APPLICATION NO.	FILING DATE	FIRST NAMED INVENTOR	ATTORNEY DOCKET NO.	CONFIRMATION NO.
10/613,396	07/03/2003	Karsten Andersen	032287-102	4469
75	90 10/04/2005		EXAMINER	
Robert E. Krebs			GUTMAN, HILARY L	
Thelen Reid & I	Priest LLP			
P.O. Box 640640			ART UNIT	PAPER NUMBER
San Jose, CA 95164			3612

DETAILED ACTION

U.S. Patent May 24, 1988 Sheet 3 of 4 4,745,952

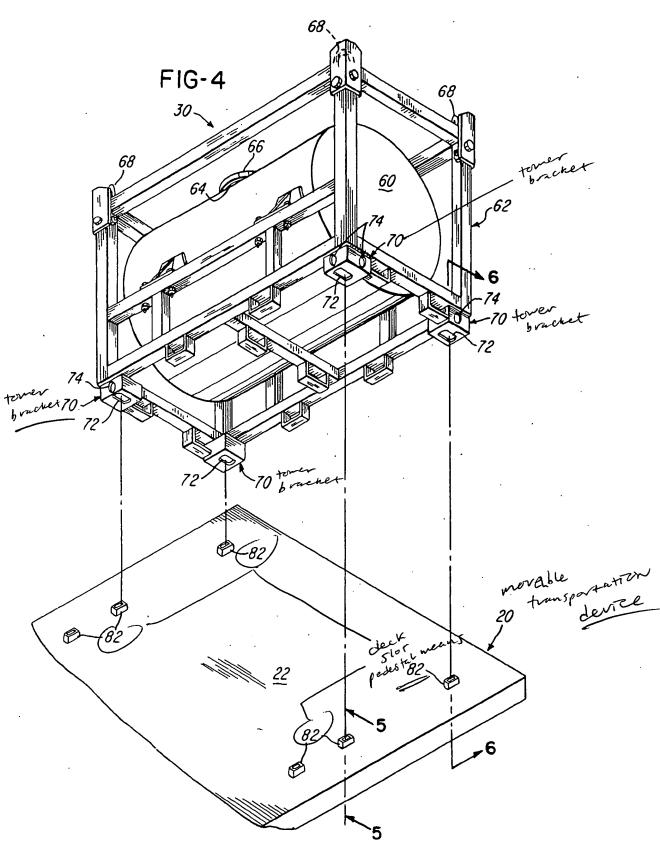
With regard to claim 10, said first deck slot pedestal means is connected to said first bracket by twist lock connectors which constitute the end stop means. (See marked-up copy of Figures 4, 6, and 8, hereto attached).

With regard to claim 9-10, the examiner has included a marked-up copy of French which more clearly shows all of the features of the claimed invention as broadly recited and interpreted. Application/Control Number: 10/613,396 Page 7
